Metropolitan Development Commission Regional Center Hearing Examiner (December 14, 2023) Meeting Agenda

STAFF REPORT

Case Number	2023-REG-092
Address (approx.)	126 West Georgia Street
Location	Center Township, Council District # 16
Petitioner	Roman Catholic Archdiocese of Indianapolis Properties, Inc., as trustee for St. John the Evangelist Catholic Church, Indianapolis, Inc., by Jamilah Mintze
Zoning	CBD-2 (RC)
Request	Regional Center Approval to provide for a two-story, 2,600-square-foot parish hall addition, new landscaping and hardscape, new sidewalk, and reconfigured surface parking area.

Case Number	2023-REG-095
Address (approx.)	838 Greer Street
Location	Center Township, Council District # 16
Petitioner	EGG Realty, LLC, by Andrew Brindley
Zoning	D-8 (RC)
Request	Regional Center Approval to provide for demolition of an existing single-family dwelling in order to construct a proposed two-story single-family dwelling.

Proposed site plan

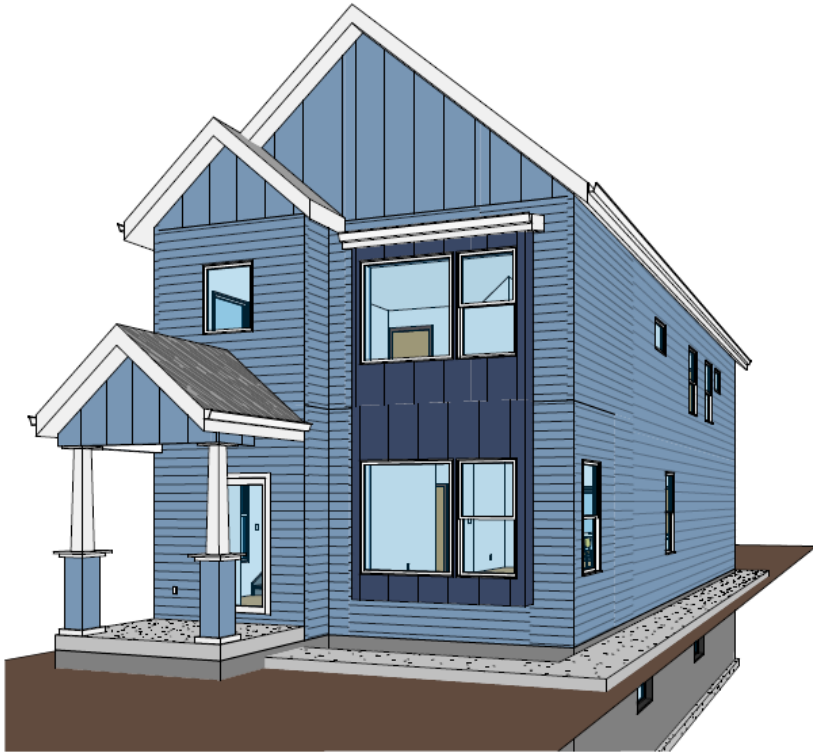
The petitioner proposes to construct a two-story single-family dwelling. A revised site plan also notes a proposed detached garage; however, no elevations have been submitted to the file for the detached garage. Proposed single- and two-family dwellings and accessory structures are exempt from The *Regional Center Design Guidelines*. Instead, staff would utilize the *Infill Housing Guidelines* to review the design of the proposed dwelling and detached garage. Staff has included a preliminary design of the proposed structure in this report, below.
